VERMONT YANKEE NUCLEAR POWER CORPORATION

VERMONT YANKEE NUCLEAR POWER STATION

Amendment No. 39  
License No. DPR-28

ATTACHMENT TO LICENSE AMENDMENT NO. 39

Figure 3.11-3A  
MCPR Operating Limit for 8x8 Fuel

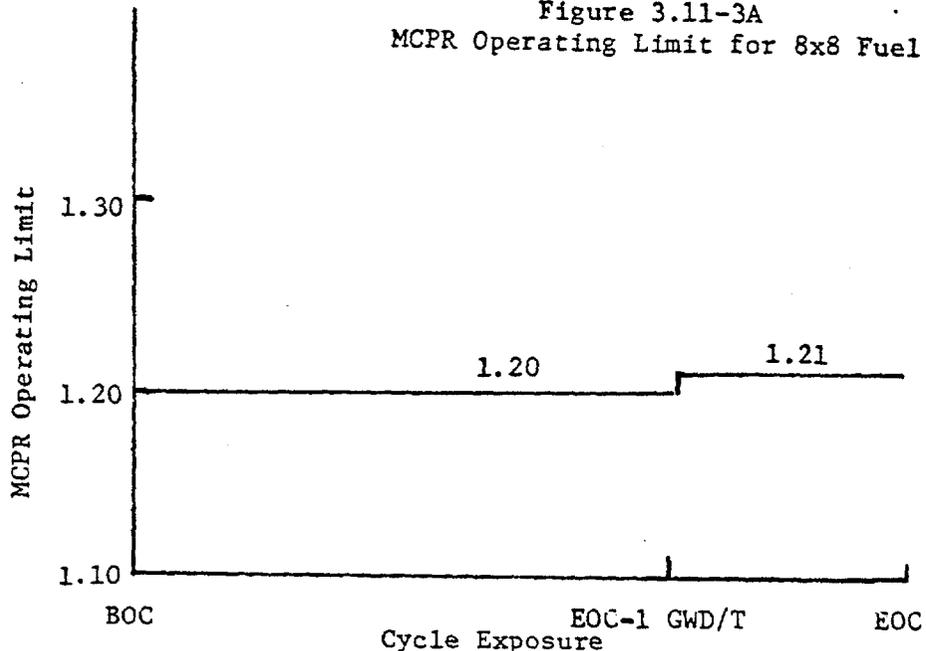
During steady state power operation the MCPR Operating Limit shall be equal or greater than the values shown on Figures 3.11-3A and -3B for 8x8 fuel and 7x7 fuel, respectively. For core flows other than rated the Operating MCPR Limit shall be the above value multiplied by  $K_f$ , where  $K_f$  is given by Figure 3.11-2. If at any time during steady-state operation it is determined by normal surveillance that the limiting value for MCPR is being exceeded, action shall be initiated within 15 minutes to restore operation to within the prescribed limits. If the steady state MCPR is not returned to within the prescribed limits within two (2) hours, the reactor shall be brought to the cold shutdown condition within 36 hours. Surveillance and corresponding action shall continue until reactor operation is within the prescribed limits.
